STAFF REPORT

Meeting: June 18, 2015

To: Design and Historic Review Commission members

Case: RCC15-11

SIGN CABINETS

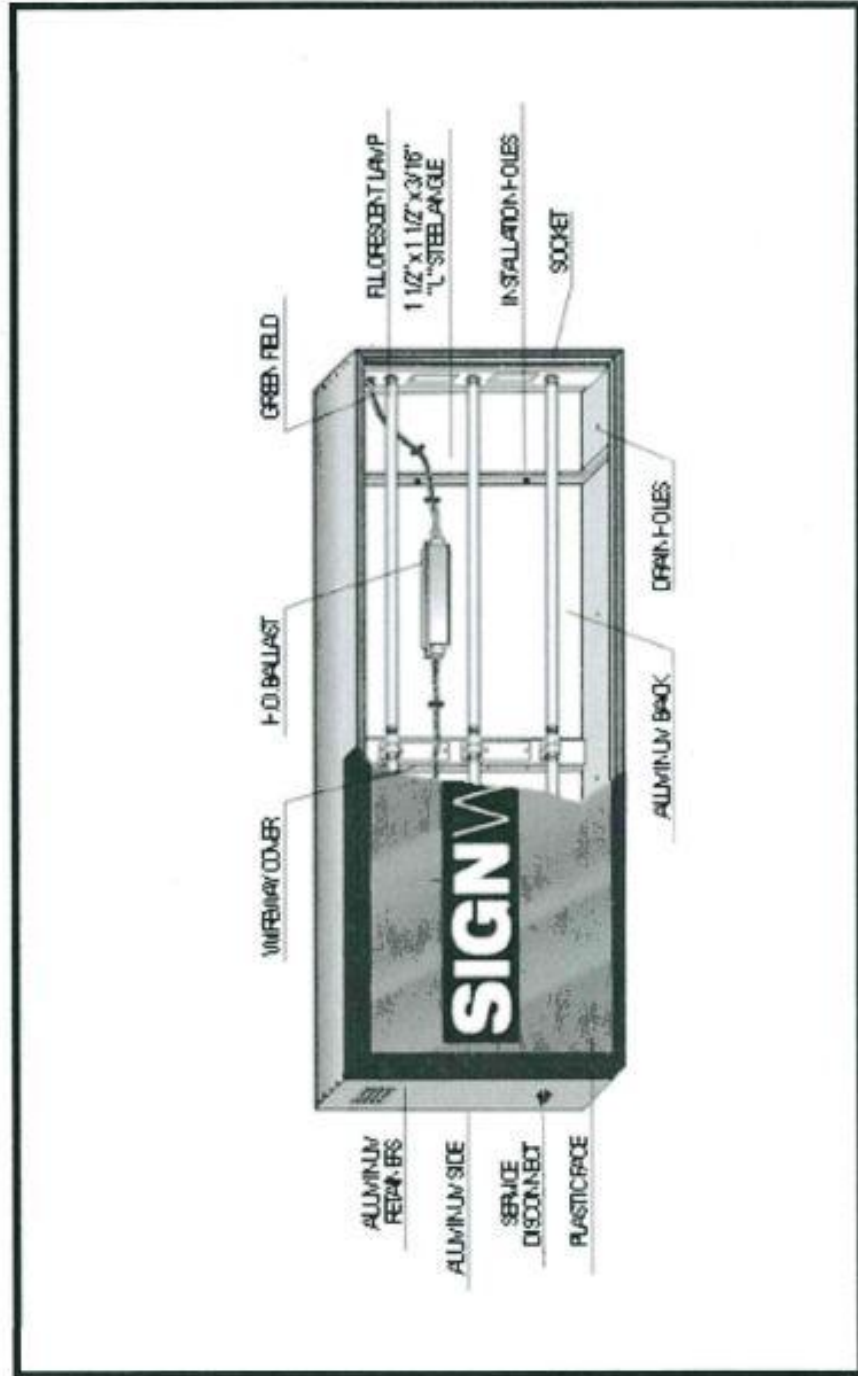
Staff believes the proposed lit signs will enhance the building design, breaking up the lengthy expanse facing Rio Concho Drive. However, both signs will face the north side of the river and the park in the area. The proposed aluminum sign with fluorescent bulb is typical of most commercial signage outside the River Corridor, however, there is a concern of spillover glare given that the signs will emanate towards the water, as there are no buildings immediately across the street.

As a condition of approval, Staff recommends the applicant use an LED light inside the aluminum frame of the sign, as opposed to a fluorescent bulb, to eliminate potential glare and spillover illumination onto the river.

1. **There shall be no glare of spillover illumination onto adjacent properties, and the applicant shall provide the Director of the Planning & Development Services, or his/her designee, with revised sign details, replacing the florescent bulb with an LED bulb.**

Building Elevations

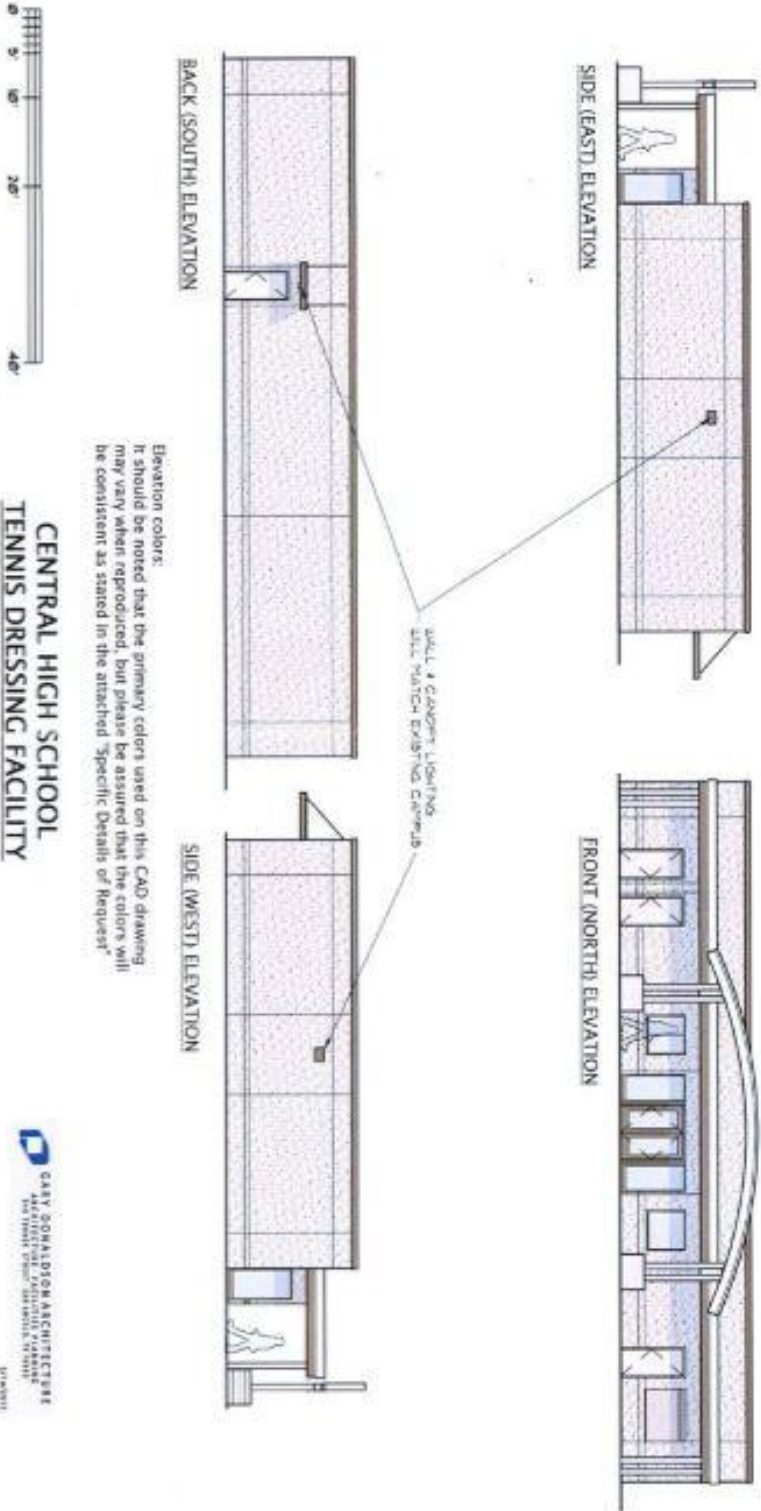
The steep grade, parking lot and functional intent of the school make this case unique. Nevertheless, Planning Staff believes there should be an addition of some architectural design element on the south elevation to break up the lengthy building wall expanse. As a Condition of Approval, the applicant has agreed to install another arched entry feature above the door and existing canopy, of similar height and style with the same light metal bronze material, and beams with stucco columns at the base. Staff believe this will break up the building expanse and meet the intent of the Site Design and Layout Policy of the RCMDP.

1. **The applicant shall submit a revised elevation drawing to the Director of the Planning & Development Services Department, or his/her designee, for review and approval showing an arched entry feature of the same**

colors and materials, and of similar height and style above the door on the south elevation to break up the wall expanse.
